<b>Well Name:</b> PARSLEY ARA FED	<b>Well Location:</b> T23S / R32E / SEC 26 / SESE /	<b>County or Parish/State:</b> LEA / NM
<b>Well Number:</b> 01	<b>Type of Well:</b> OIL WELL	<b>Allottee or Tribe Name:</b>
<b>Lease Number:</b> NMNM88164	<b>Unit or CA Name:</b>	<b>Unit or CA Number:</b>
<b>US Well Number:</b> 3002533863	<b>Well Status:</b> Oil Well Shut In	<b>Operator:</b> EOG RESOURCES INCORPORATED

**Notice of Intent**

**Type of Action:** Plug and Abandonment

**Parsley ARA Fed #1 – Proposed P&A****API#: 30-025-33863****Sec 26, T23S, R32E****TD: 10,325'    PBSD: 10,283'    GL: 3690'                      KB:**

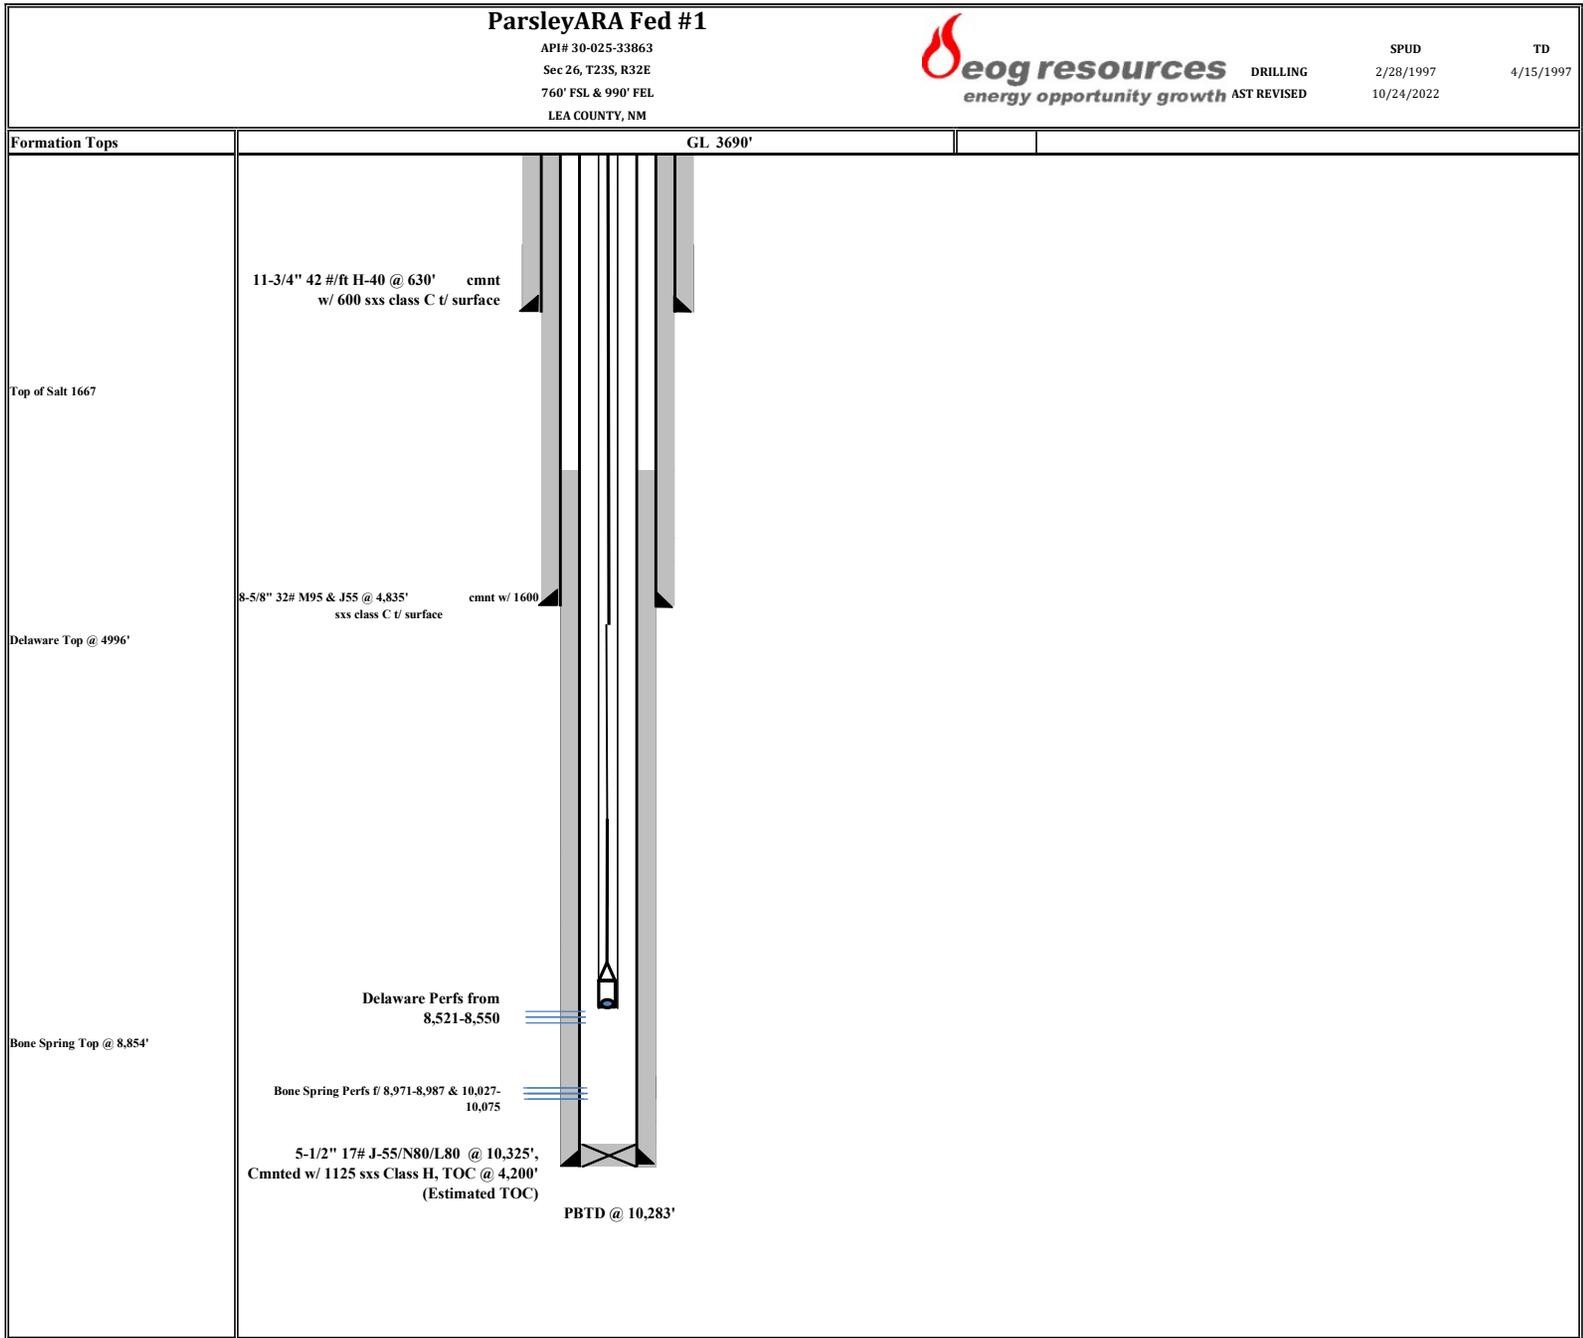
4. Spot 26 sx Class H cmnt f/ 8921-8696, WOC and TAG (Bone Spring Top)
5. Move up hole to 8471', set a CIBP at 8471, spot 25 sxs class H cmnt, plug f/ 8471-8246. **Leak test CIBP.**

6. Move up hole to 6400', preform balanced plug w/ 25 sxs class C cmnt, plug f/ 6400-6236 **(3000' between plugs)**
7. Move up hole to 5046', preform balanced plug w/ **40** sxs class C cmnt, plug f/ 5046-**4653**. WOC & TAG (Delaware and 8-5/8" casing shoe plug, **Base of Salt**)

8. Pick up, perf @ 1717' and sqz a 30 sxs class C cement plug f/ 1717-1592. WOC & Tag. (Top of Salt) **(In 12 sxs/Out 16 sxs)**
9. Pick up, perf @ 680' and sqz a 26 sxs class C cement plug f/ 680-580. WOC & Tag. (Surface shoe plug) **(In 11 sxs/Out 15 sxs)**

10. Pick up, perf @ 250' and sqz a 59 sxs class C cement plug to surface. Top off as needed. Ensure all annuluses are full to surface. **(In 25 sxs/Out 34 sxs)**

Plug Type	Top	Bottom	Length	Tag	Sacks	Notes
Surface Plug	0.00	250.00	250.00	Tag/Verify	59.00	Perf and Squeeze from 250' to surface. Verify at surface.
Shoe Plug	573.70	680.00	106.30	Tag/Verify	26.00	Perf and Squeeze from 680' to 573'. WOC and Tag.
Top of Salt @ 1667	1600.33	1717.00	116.67	Tag/Verify	28.00	Perf and Squeeze from 1717' to 1600'. WOC and Tag.
Base of Salt @ 4751	4653.49	4801.00	147.51	Tag/Verify		
Shoe Plug	4736.65	4885.00	148.35	Tag/Verify		
Delaware @ 4996	4896.04	5046.00	149.96	If solid base no need to Tag (CIBP present and/or Mechanical Integrity Test), If Perf & Sqz then Tag, Leak Test all CIBP if no Open Perforations	40.00	Spot cement from 5046' to 4653'. WOC and Tag.
3000' between plug @ 6350	6236.50	6400.00	163.50	If solid base no need to Tag (CIBP present and/or Mechanical Integrity Test), If Perf & Sqz then Tag, Leak Test all CIBP if no Open Perforations	25.00	Spot cement from 6400' to 6236'.

<b>Perforations Plug (If No CIBP)</b>	8414.50	8600.00	185.50	Tag/Verify		
				If solid base no need to Tag (CIBP present and/or Mechanical Integrity Test), If Perf & Sqz then Tag, Leak Test all CIBP if no Open Perforations		Set CIBP at 8471'. Leak Test CIBP. Spot 25 sxs on top.
<b>CIBP Plug</b>	8436.00	8471.00	35.00		25.00	
<b>Bonesprings @ 8854</b>	8715.46	8904.00	188.54	base no		
				If solid base no need to Tag (CIBP present and/or Mechanical Integrity Test), If Perf & Sqz then Tag, Leak Test all CIBP if no Open Perforations		Set CIBP at 8921'. Spot cement 8921' to 8715'. WOC and Tag.
<b>CIBP Plug</b>	8886.00	8921.00	35.00		26.00	
<b>Perforations Plug (If No CIBP)</b>	8921.00	10125.00	1204.00	Tag/Verify		
<b>Perforations Plug (If No CIBP)</b>	9924.25	10125.00	200.75	Tag/Verify		
<b>Shoe Plug</b>	10171.75	10375.00	203.25	Tag/Verify

No more than 2000' is to be allowed between plugs in open hole, and no more than 3000' between plugs in cased hole.
